Westinghouse Electric Company Nuclear Power Plants P.O. Box 355 Pittsburgh, Pennsylvania 15230-0355 USA

Subject: AP1000 Response to Request for Additional Information (SRP 9)

RAI-SRP9.1.1-SRSB-05

RAI Response Number: RAI-SRP9.1.1-SRSB-05 Revision: 0

Figure 3.7.12-1 Minimum Fuel Assembly Burnup Versus Initial Enrichment for the Region 2 "All Cell" Storage Configurations

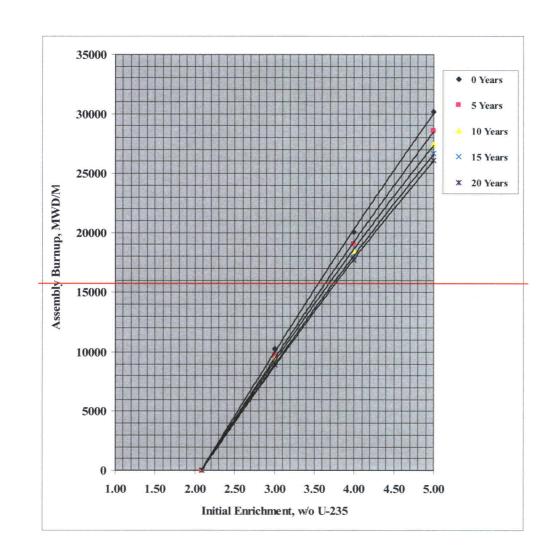
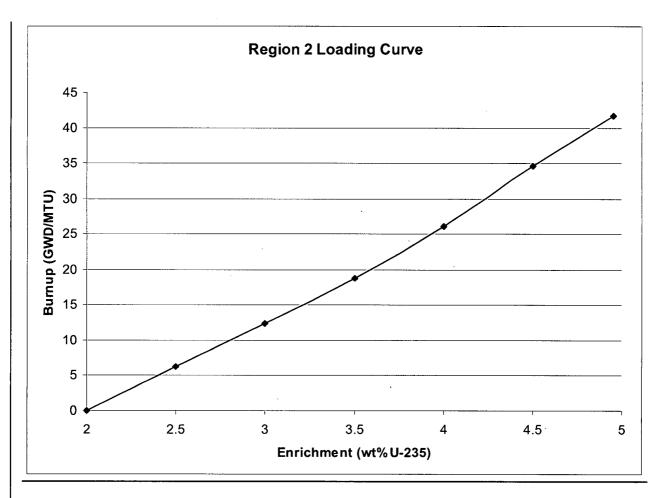
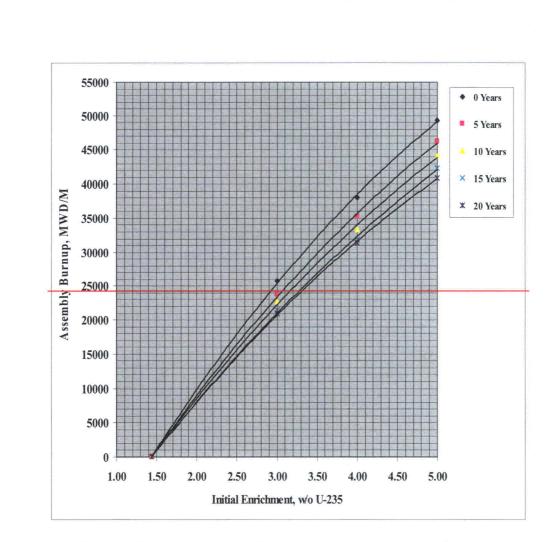
DCD Section 9.1.6.4 "Criticality Analysis for Spent Fuel Racks" references TR-65 (APP-GW-GLR-029), which utilizes the methodology described in WCAP 14416-NP-A. A 2001 NRC letter (ML012080337) states that WCAP 14416-NP-A can no longer be relied upon as "approved methodology." The staff has found that the AP1000 methodology does not accurately calculate a spent fuel pool criticality analysis that meets 10 CFR 50.68.

Additionally, TR-65 relies on the same overall methodology used for multiple, recently submitted operating fleet spent fuel pool criticality analyses which were not accepted by the NRC. One example; a May 17, 2007 letter (ML071230037) issued an RAI against the June 14, 2006 Beaver Valley Power Station (BVPS) license amendment request. This BVPS RAI, and the process that followed, resulted in licensee commitments to work towards a license amendment that meets the requirements of 10 CFR 50.68. The NRC feels that Westinghouse is familiar with this spent fuel pool criticality analysis issue as it relates to BVPS and other utilities. The NRC requests Westinghouse re-submit the AP1000 spent fuel pool criticality analysis with a new methodology that meets 10 CFR 50.68.

The combination of initial enrichment and burnup of each fuel assembly stored in Region 2 shall be within the limits specified in Figure 3.7.12-1. or

The combination of initial enrichment, burnup, and decay time of each fuel assembly stored in Region 2 in the Spent Fuel (1.361 w/o) locations in a "1-out-of-4 5.0 weight percent fresh" configuration shall be within the limits specified in Figures 3.7.12-2.

Minimum Fuel Assembly Burnup Versus Initial Enrichment for the Region 2 <u>"All Cell" Storage ConfigurationsSpent Fuel Cells</u>

Minimum Fuel Assembly Burnup Versus Initial Enrichment for the Region 2 "1-out-of-4 5.0 Weight-Percent Fresh" Storage Configurations
